Applicant/Serial No.: Haruhiro Watanabe / 10/624,168

Amendment mailed: 12 / 08 / 2005

REMARKS

AMENDMENTS TO THE DRAWINGS

FIG. 12(c) FIG. 12(d)

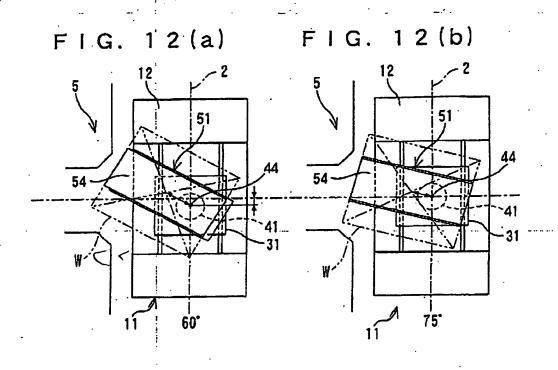
dated September 8, 2005, the drawings were objected to because they failed to depict the "transfer

of an article from between the article supporting body and the article handling section" as recited in

of the invention. Likewise, in accordance with the second embodiment of the invention, Fig. 12(d)

follows the action subsequent to that of Fig. 12(c), and upper fork member 54 has been moved to

Drawing figure sheets showing original Figs. 10(a)-10(c) with a new Fig. 10(d) and original Fig. 12(a)-12(c) with a new Fig. 12(d) are attached labeled as "Annotated Sheet Showing Changes" and "Replacement Sheet." These are both in draft form. Once approved, a formal set of both drawing figure sheets marked "Replacement Sheet" will be filed.

FIG. 10(d)

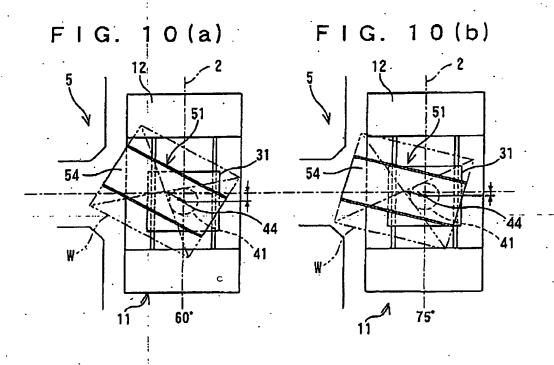
These figures show the transfer of an article W supported by upper fork member 54 to the

article unloading section 5 following the step shown in Fig. 10(c) pursuant to the first embodiment
